DEVELOPMENT REVIEW COMMITTEE (DRC) COMMENT REPORT

PROJECT NAME: 199 NW 5th Avenue

CASE NUMBER: UDP-S22002

REQUEST: Site Plan Level II Review: 400 Multifamily Residential Units with 4,798 Square Feet of Retail Use in the Downtown Regional Activity Center

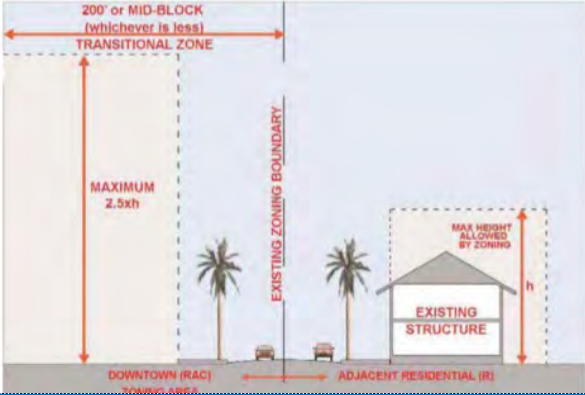
Q4	Respect for Historic Buildings			x	
Q5	Parking Podium Façades: Where structured parking must be exposed to the street, exceptionally creative solutions should be explored		x		Parking podium should contain exceptional design solutions to screen the podium through various design techniques and materials on the south elevation.
Q6	Response to Natural Environment: Encourage architecture to respond to the unique nature of the				More information needed.
